## Technical Bulletin

Model: <b>Stella-C3</b> Date: 23-Aug-06 No.: RB262001e	<del></del>
--	-------------

This RTB has been issued to announce the firmware release information for the **Engine** (**BICU-IC**).

**Bottom View of Cassette**

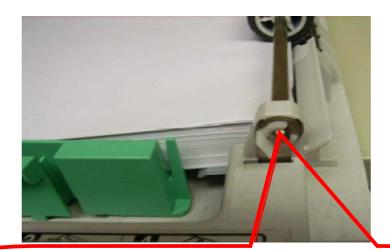
One or both grounding plates on the bottom of the main body paper cassette may not be making proper contact.

The above photograph is showing the front bottom view of the cassette.

Reform or replace the grounding plates so that they make proper electrical contact.

Make sure to form the grounding plate to the rear so that it makes contact with the bottom machine frame.

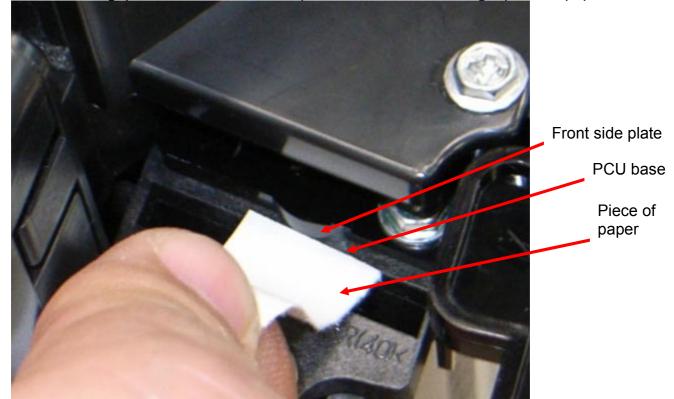
- A step was added to ensure that there is no gap between the front side plate and PCU base.
- The plastic rod on the PCU front side plate will be removed (cut).

Cut and remove the plastic rod using a pair of needle-nosed pliers.
 Note: There is no side effect created by removing this rod from the PCU (even from a normal PCU).

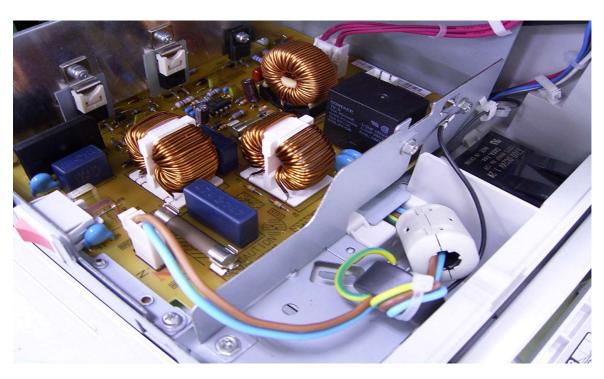
**Reason** / **Change:** The ferrite core has been added to the power supply cord in the power supply unit to protect the AC line from electrical noise.

Old P/N	New P/N	Description	Q'ty	Int	Page	Index	Note
	16071460	Ferrite Core: RFC-9	0-1		41	108	New Index
